Canterbury District Local Plan 2040: Regulation 19 Representation

Representation By: Westbere Village Preservation Society

Policy / Site Reference: Policy R6 – Bread and Cheese Field (SLAA163)

Settlements: Westbere and Hersden

Fig. 2 (Arrow added)

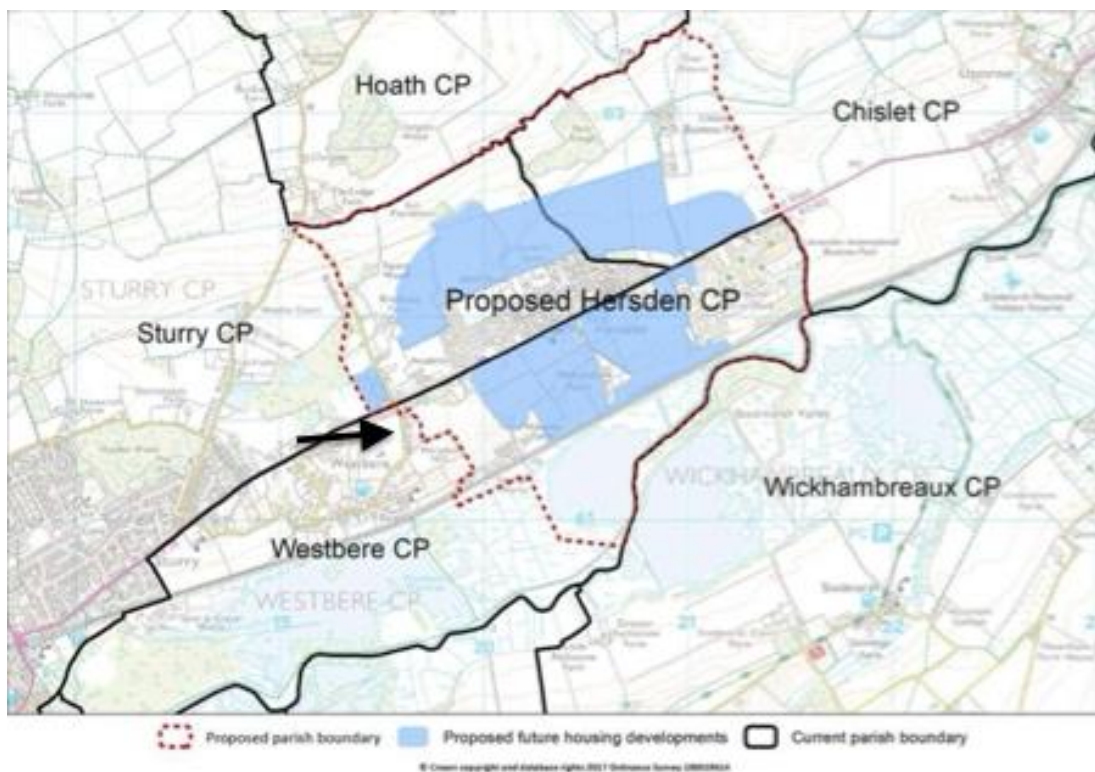
This revised map:

1. Differed materially from the map previously circulated during consultation
2. Altered the previously consulted boundary alignment without any further public consultation
3. Included the entire Bread and Cheese Field within the newly created Hersden Parish

WVPS submits that:

1. This constituted a change of material relevancy to the consultation proposal
2. By moving the Field from a Local Service Centre to a Rural Service Centre it materially affected the future planning context of the site

3. The decision to include all the Field within Hersden established a planning narrative that later under-pinned the Local Plan R6 Policy; it was however, a decision that was fundamentally flawed and which was eventually reversed by Canterbury Council but which would continue to guide the Policy.

Fig.5

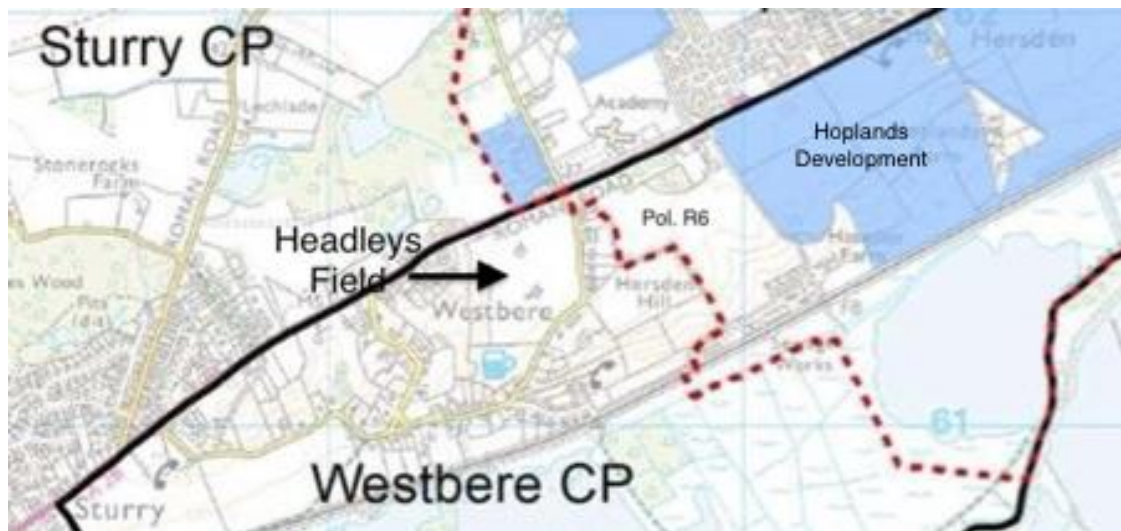
WVPS submits that this location is fundamentally unsuitable for fulfilling the strategic purpose of a Green Gap. Headley's Field:

1. Lies well within the Westbere Parish
2. Does not form the primary separation between settlements
3. Does not prevent physical merging of built areas
4. Does not provide meaningful spatial separation between Westbere and Hersden

1. Its designation does not achieve the intended policy objective
2. It fails to address the actual risk of settlement coalescence
3. It represents an ineffective spatial solution

Retaining Headley's Field as the primary separation area is inconsistent with established Green Gap methodology.

Reclassify Headley's Field as Countryside

1. Does not serve Green Gap function
2. Lies within Westbere settlement context
3. Does not prevent coalescence
